# Bureau of Environmental Health

# **MEMORANDUM**

RE: 1036 Stepping Place, Potential Basement Bedroom

DATE: April 10, 2020

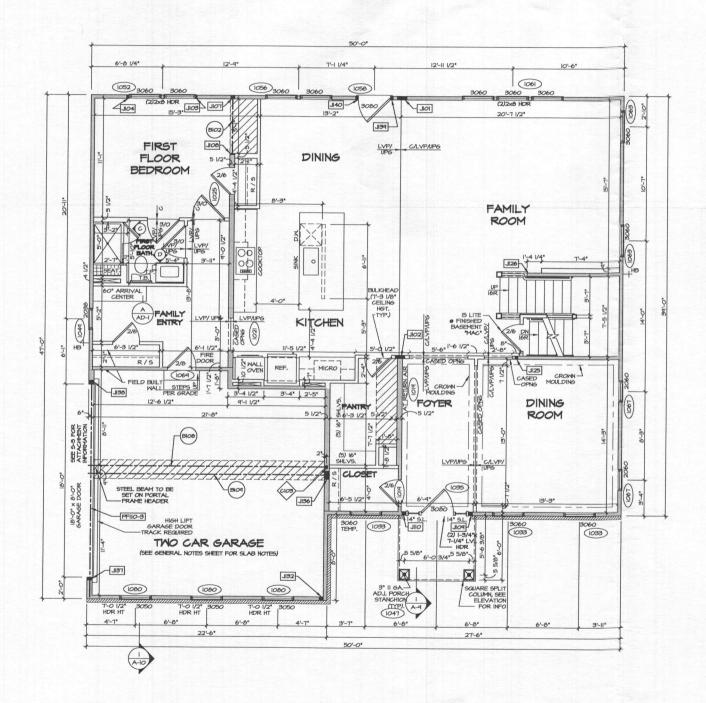
I have reviewed the floor plans in support of Building Permit B20000944 for a new home at 1036 Stepping Place and noted that there is a finished full bathroom in the partly finished basement. Please note that this makes it very likely for one or more rooms to be considered bedrooms upon further modification of the basement finished living space.

The Health Department strongly recommends sizing the onsite sewage disposal system at least one bedroom larger than the existing five-bedroom design to accommodate a future finished basement. If you choose to only size for the existing design, any future building permit for a finished basement may be placed on hold until the system is upgraded to accommodate the proposed number of bedrooms. This memo will be retained in the Health Department file for future reference.
